# LiDAR Quality Assessment Report

KY\_KYAPED-Area2\_2012

This report is for **Area-2** of the 2012 Kentucky Statewide lidar project. The area is 973 square-miles and includes Knott, Letcher, and Perry Counties.

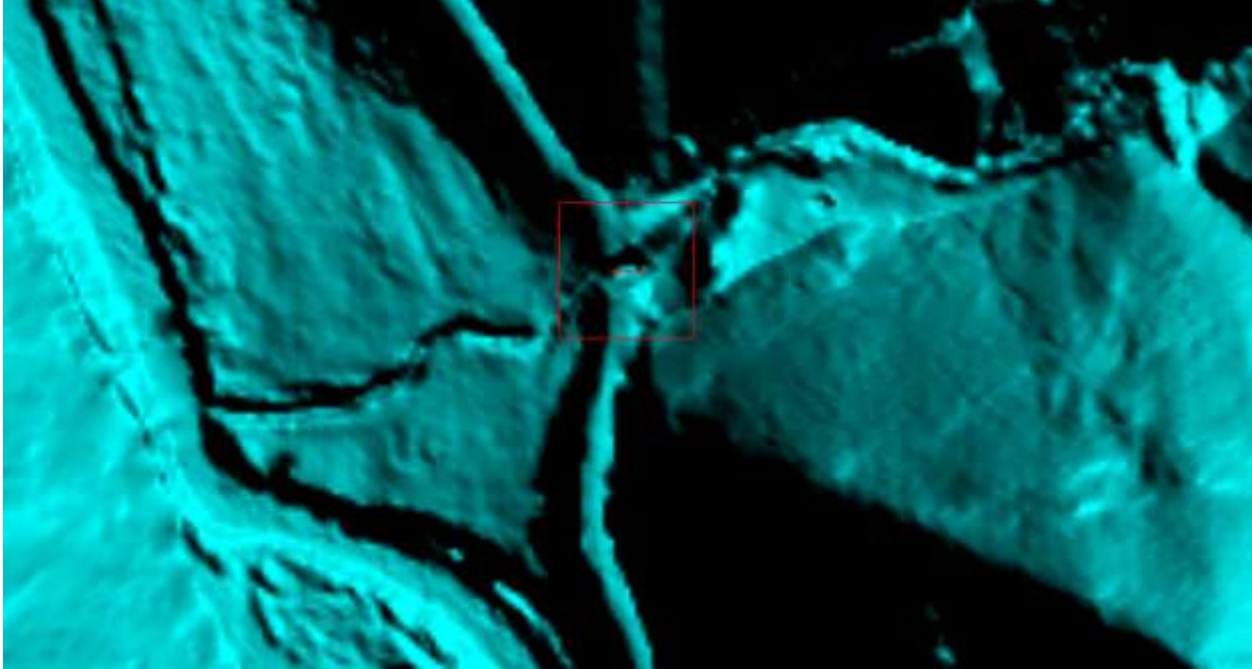
bridge\_3: The span across the trench has been identified as a bridge. As per USGS Lidar Base Specification Version 1.0, bridges are to be removed from the DEM. A total of 59 bridges have been identified that have not been removed from the DEM. Some bridges have only been partially removed from the DEM. (7/8/2013)

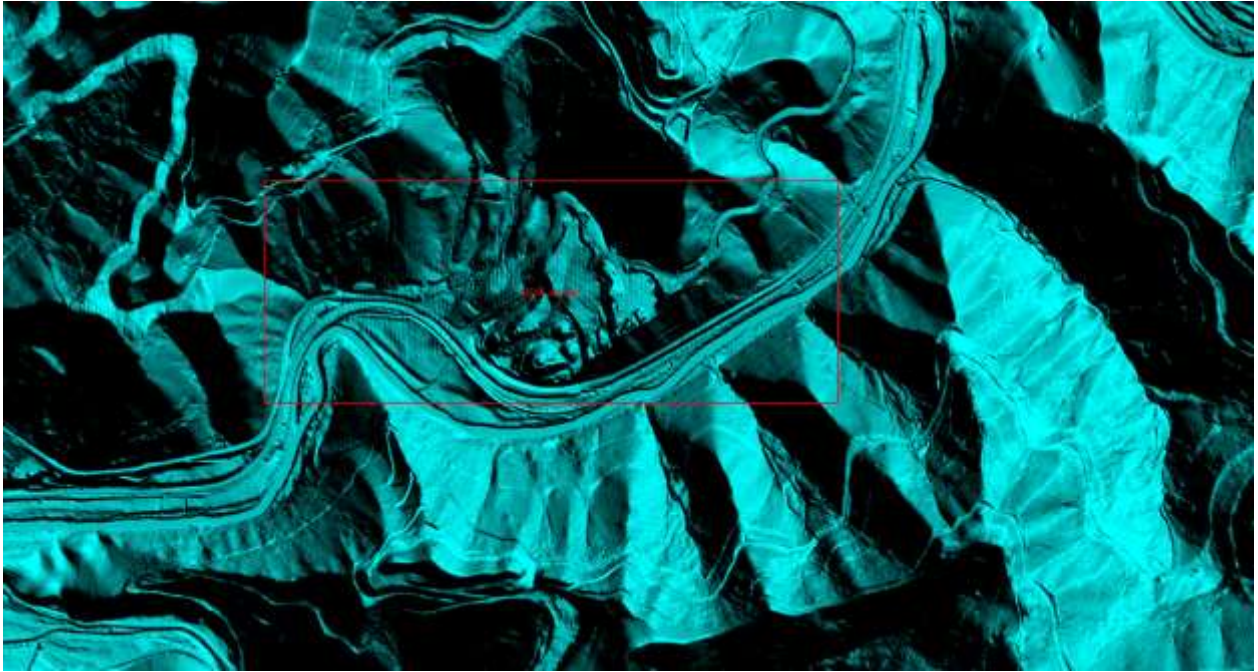
culvert\_4: The roadway across the trench has been identified as a culvert. As per USGS Lidar Base Specification Version 1.0, roadways over culverts should not be removed from the DEM. In some instances, the roadway has been partially removed above some culverts; these roadways should be completely restored. A total of 16 culverts have been identified as errors, whereas the roadway should be restored in the DEM. (7/8/2013)

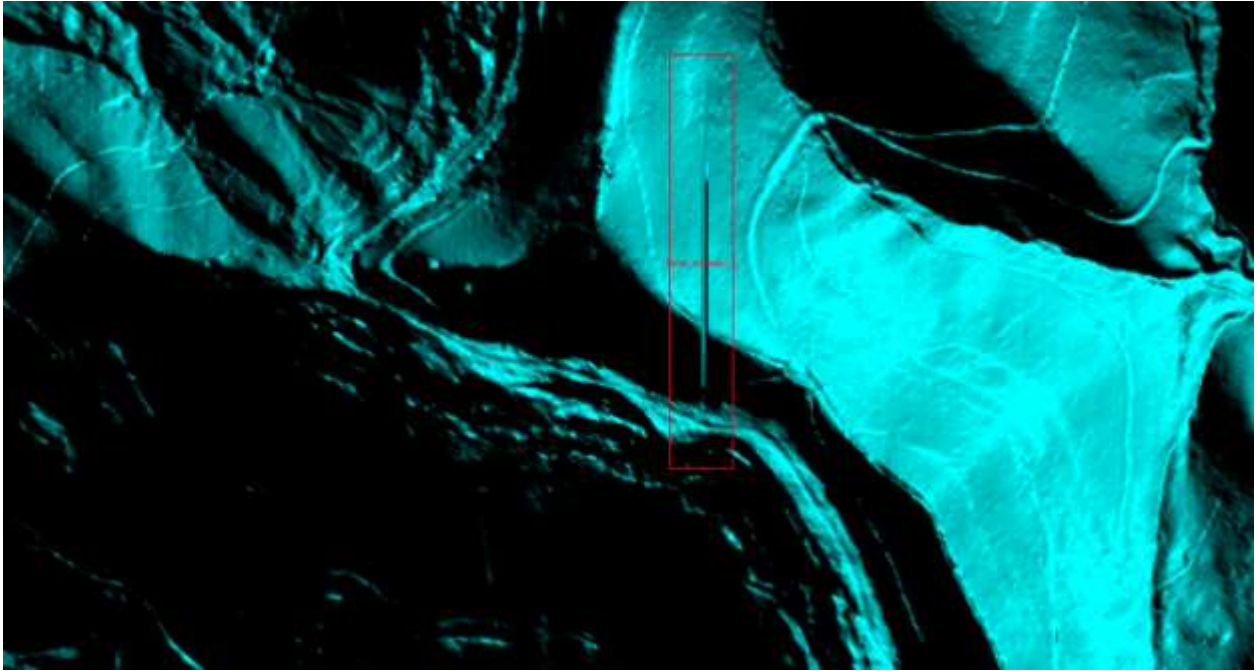
DEM\_anomaly: Parallel striations (north-south trending) - corn rowing - are present in the DEM. Two areas possessing this DEM-artifact have been identified within the DEM. (7/8/2013)

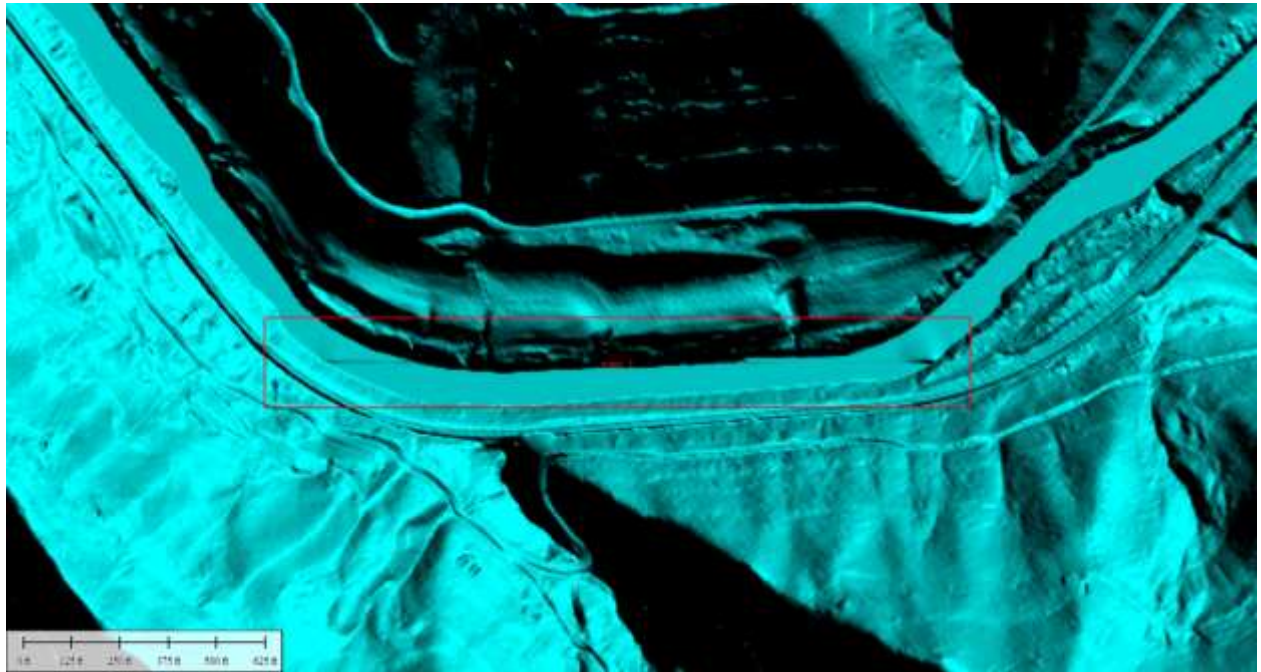
missing\_data\_1: Two areas have been identified in the DEM (mosaic) that have gaps in the data; these areas occur along seam lines, near the lineations mentioned above. (7/8/2013)

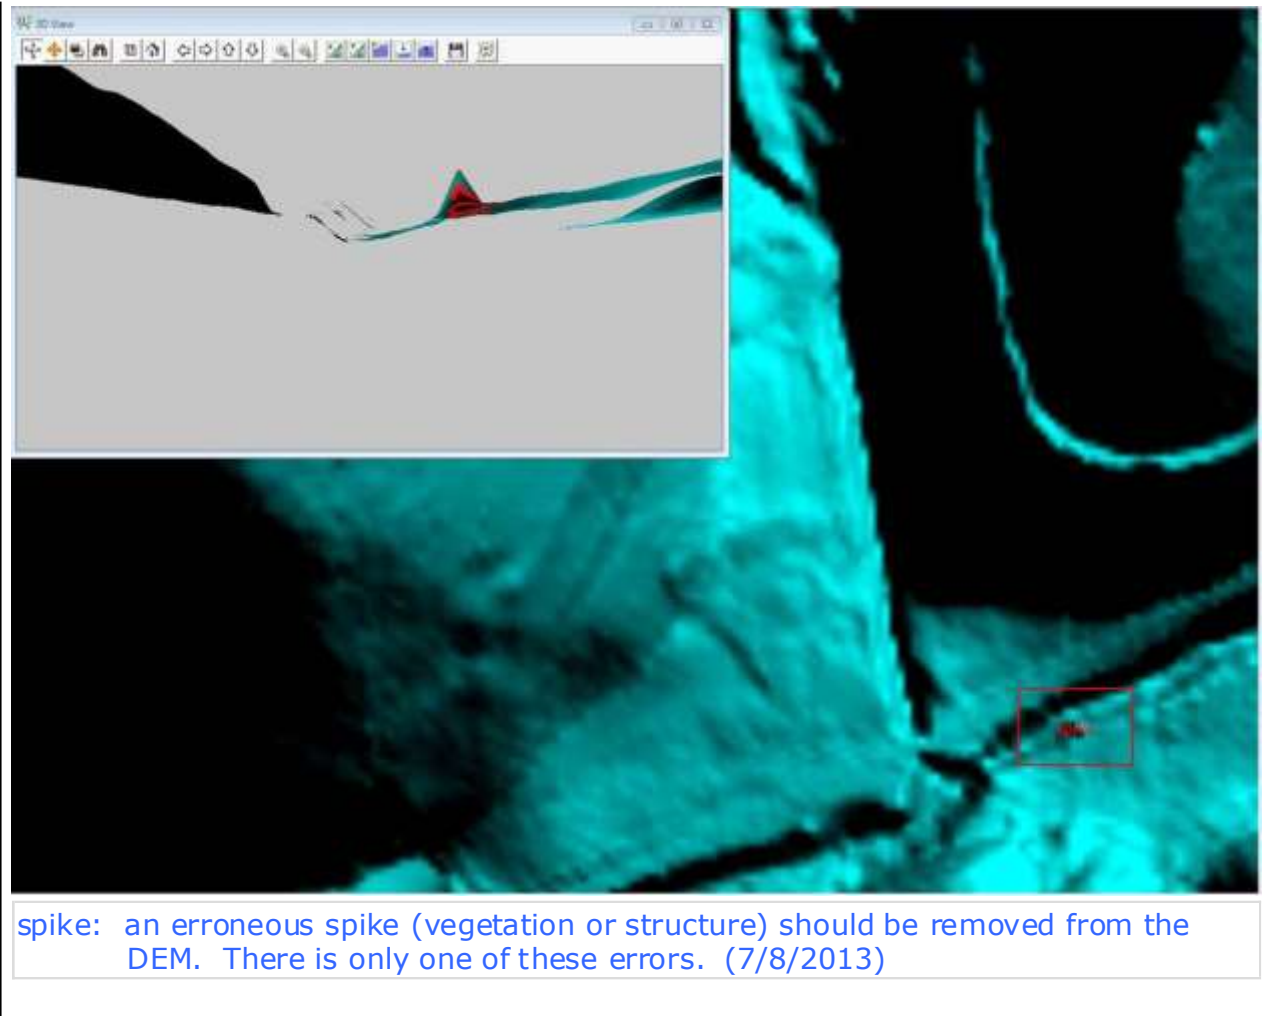
water\_1: Lineations in waterbodies that disrupt the hydroflattening of these waterbodies. There are two areas that have been identified in the DEM (mosaic). These error-types also occur along seam lines. (7/8/2013)

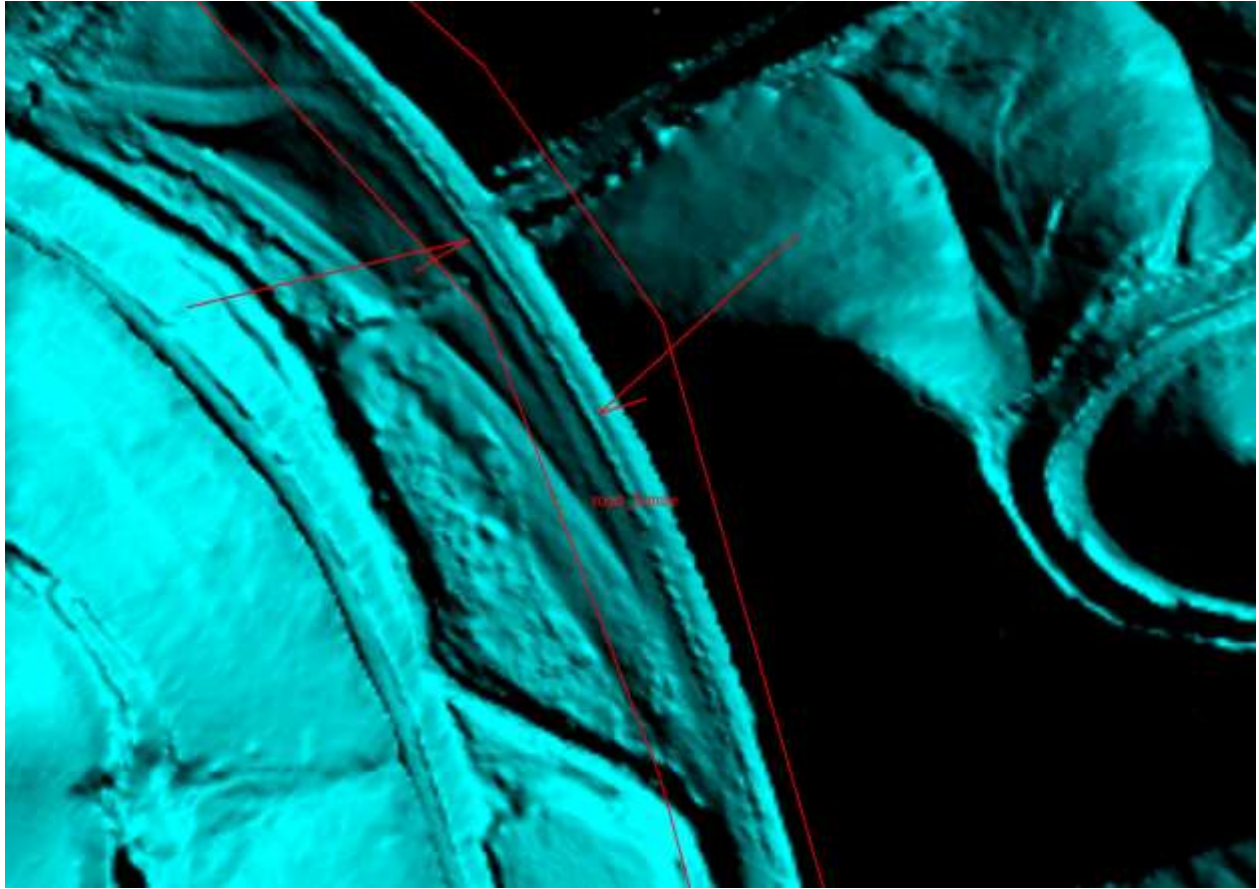
road\_feature: A curvilinear feature has been identified along a roadway. Imagery does not show this feature. Possible construction feature? There is only one area that hosts these features. (7/8/2013)
